RE: 144 Mary Street Creemore
Cumulative Impacts Assessment Brief

RE: NVCA Amended Comments for Pre-Consultation
144 Mary Street
Township of Clearview
Town File No. 2025-074PC
NVCA ID #58812

SEVERANCE SKETCH

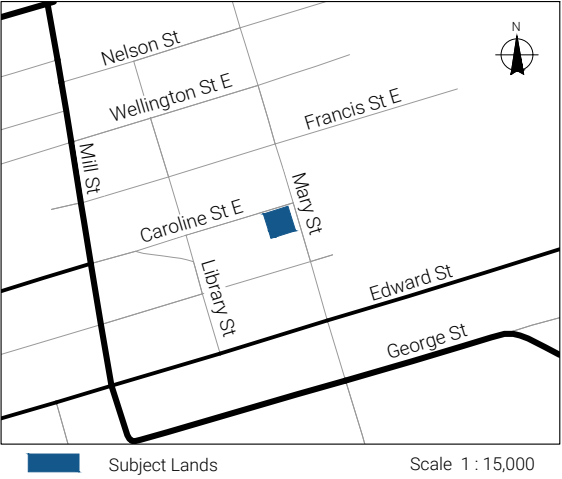
4. 2D HEC-RAS model of the Upper Mad River, prepared by Aquifor Beech, was reviewed and it was determined that a portion of the property is located within the flood fringe and the west portion is located within the floodway (flood depths in excess of 0.3m).

5. NVCA staff have confirmed with the applicant that NVCA staff are **supportive** of the **April 18, 2026 severance sketch (attached)**, which proposes the creation of one (1) lot, subject to the applicant satisfying the following requirements to the satisfaction of NVCA staff.

- c. **Development Envelope outside of the floodway;** It must be demonstrated that the proposed development envelop will be completely outside of the identified floodway.
